An option for a
limit derived anchor point
in the D/F ASEP proposal

Issued by your chairman

May 2007

Open issues after the 6th meeting

System 1: ASEP based on measured Annex 3 value:

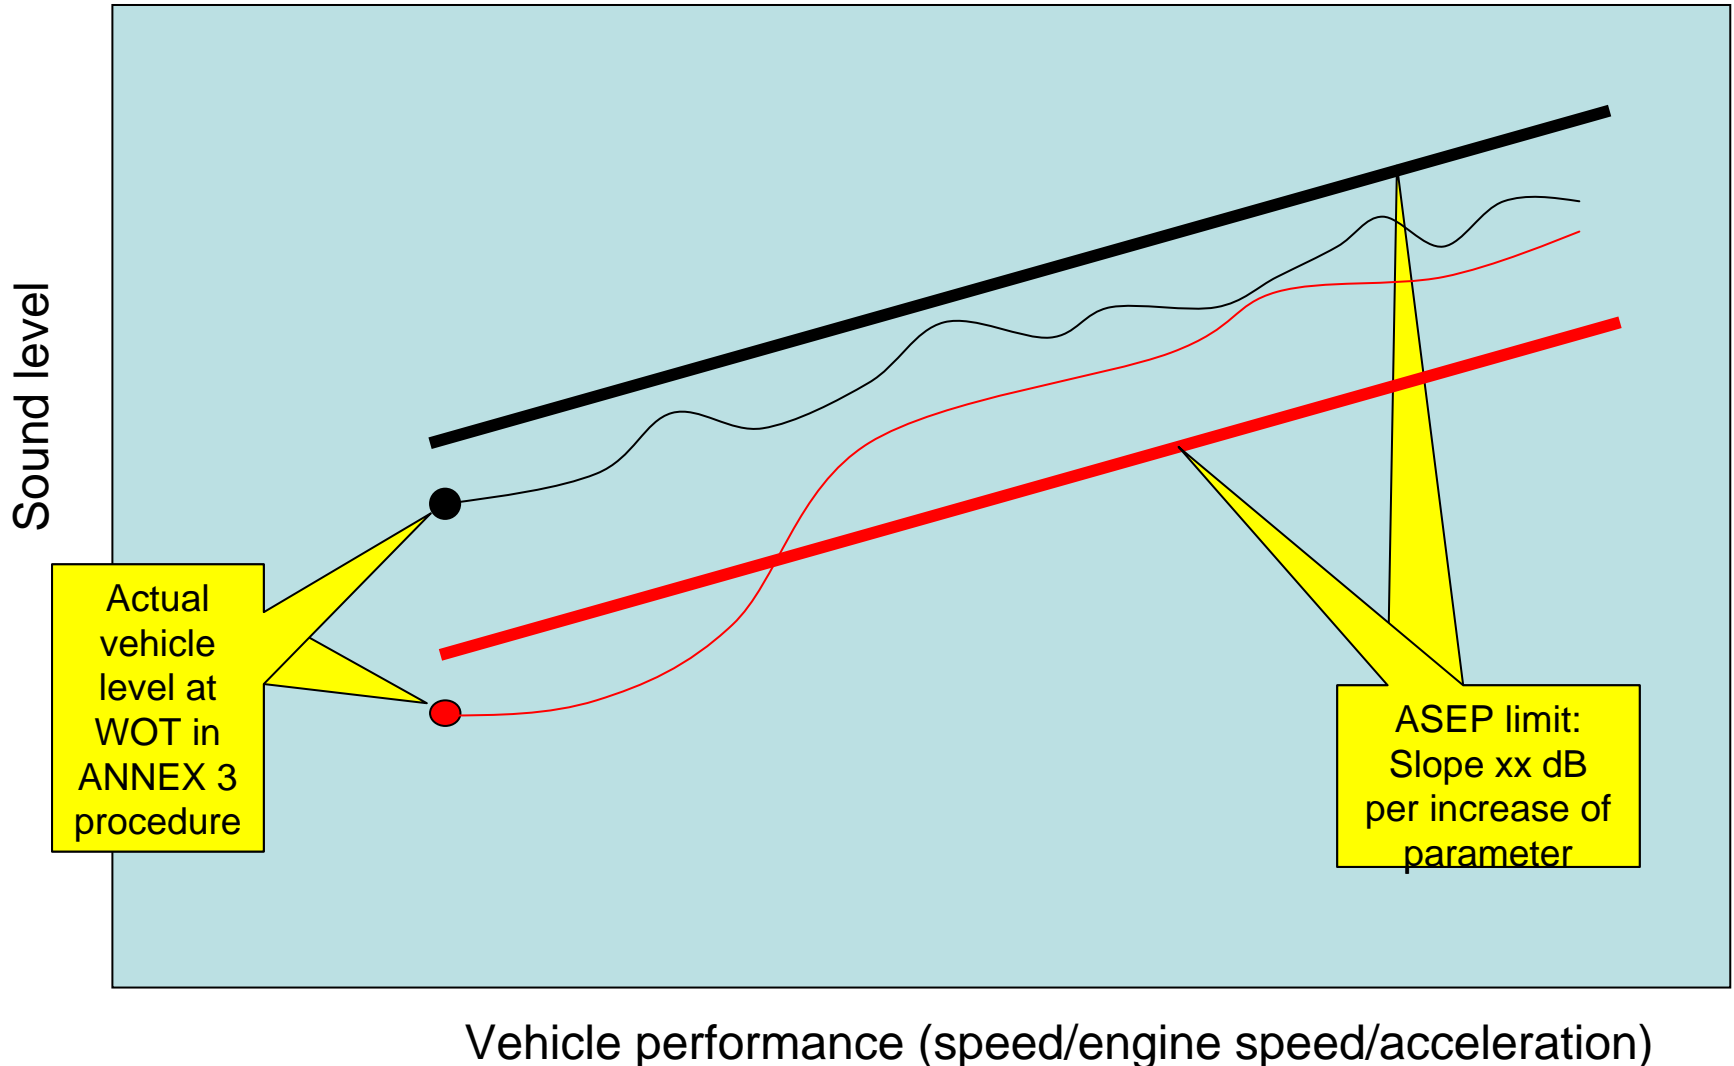
- Black vehicle passes ASEP;
- Red vehicle fails ASEP due to the progressive increase
- This system would reject the red vehicle, although it is more silent than the black vehicle

System 2: ASEP based on Annex 3 limit value

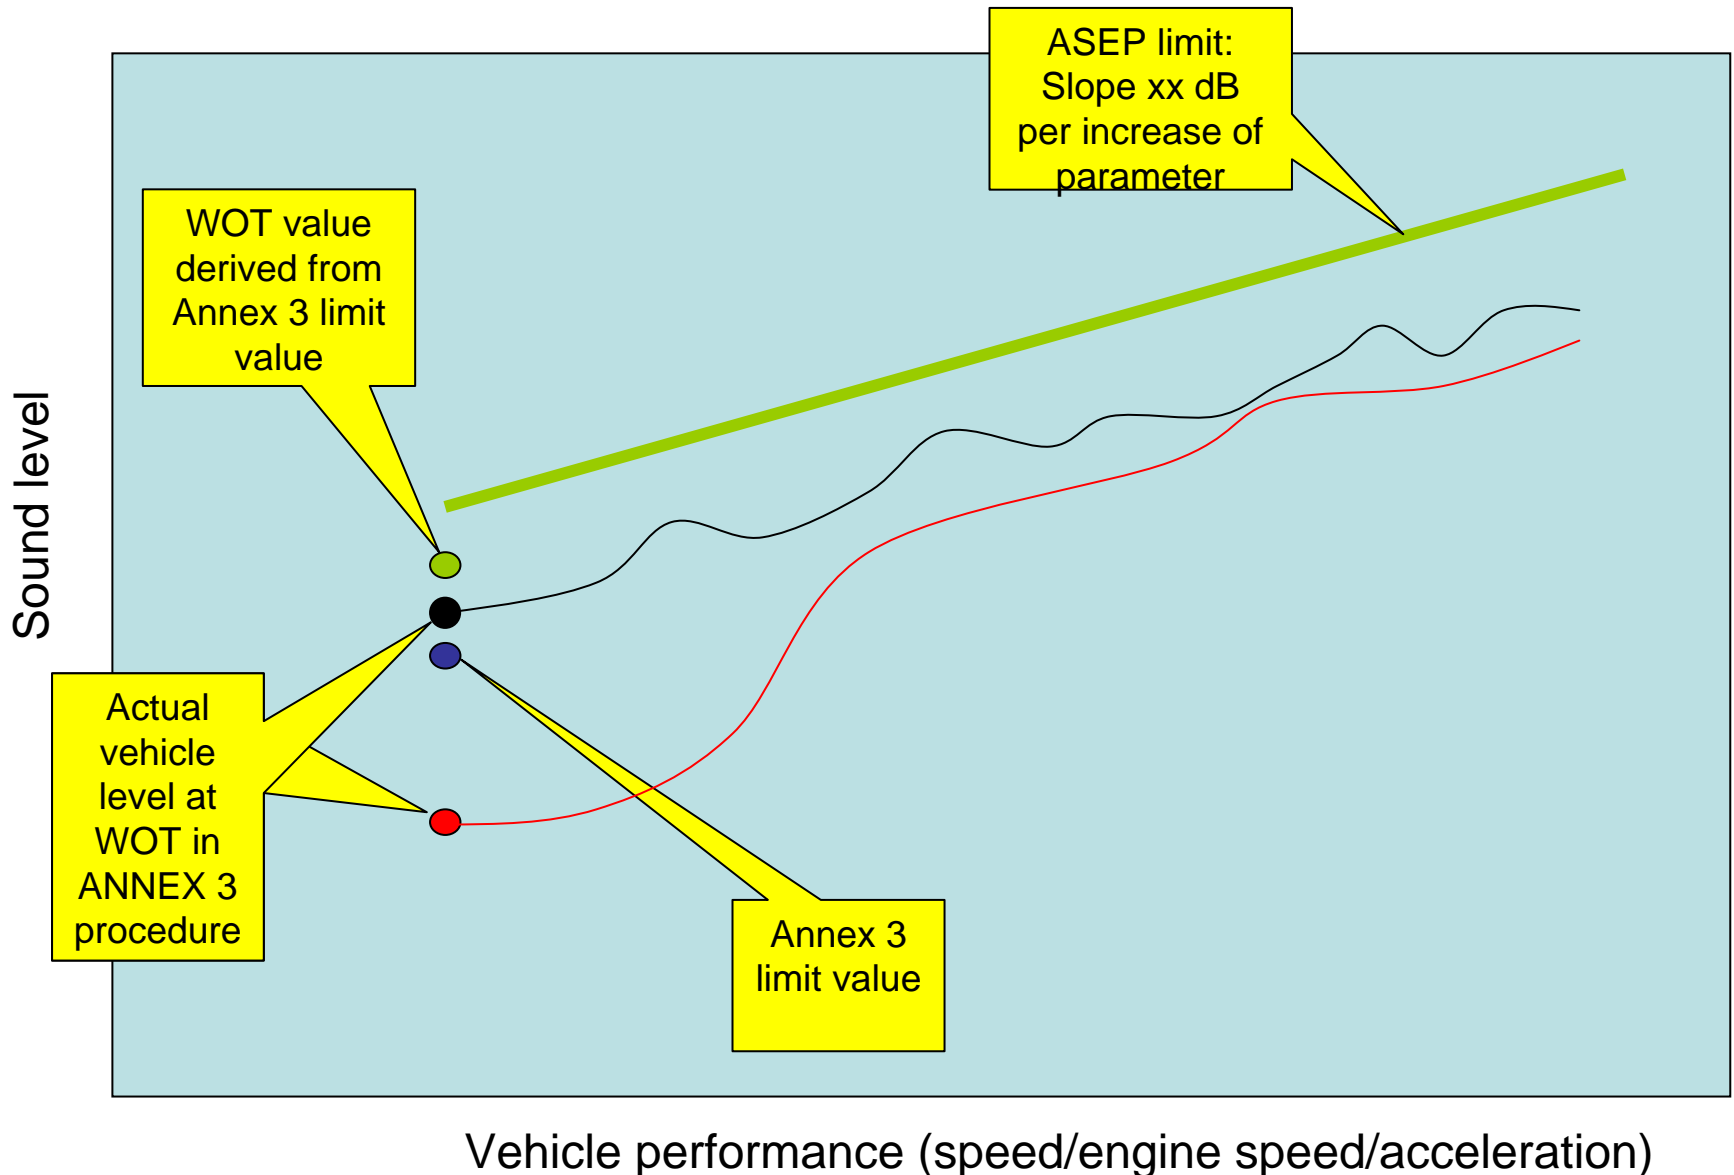
- Both vehicles pass ASEP

derive a WOT value from the limit value of annex 3

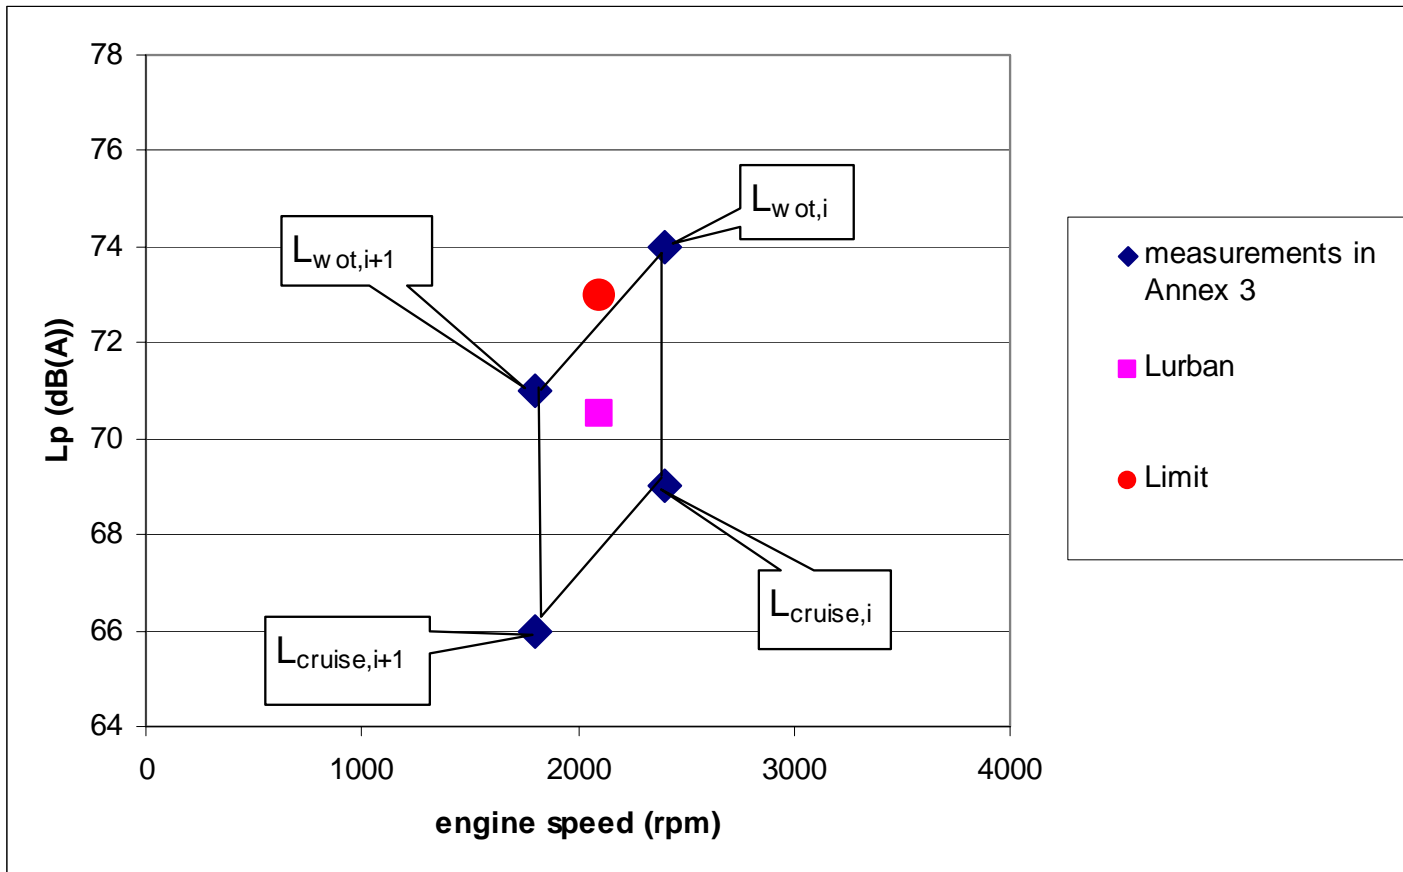
- The current ASEP anchor point is $L_{wot,i}$
- There is no direct relation between $L_{wot,i}$ and the limit value of annex 3
- An indirect relation can be made via the final test result (L_{urban})

Potential solution

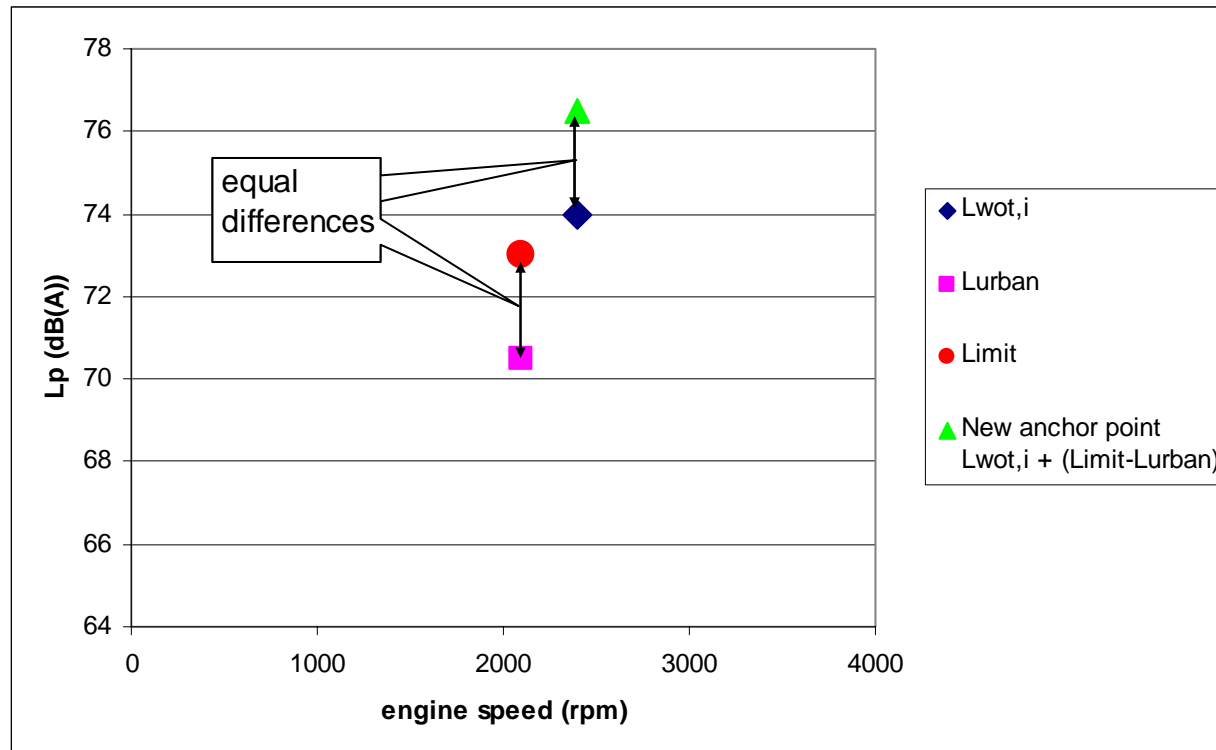
- It is assumed that the difference between the Limit and the final measurement result ($\text{Limit} - L_{\text{urban}}$) is the quantity that determines how much “extra silent” the vehicle under investigation is.
- It is also assumed that this difference is equally build up from all intermediate measurement results ($L_{\text{wot},i}$ etceteras) that where necessary to calculate the L_{urban} . Or in other words, that all annex 3 intermediate measurement results are all as much “extra silent” compared to a “normal” vehicle.
- With these two assumptions a new limit derived anchor point for ASEP can be determined out of the current anchor point $L_{\text{wot},i}$:
 - New anchor point = $L_{\text{wot},i} + (\text{Limit} - L_{\text{urban}})$
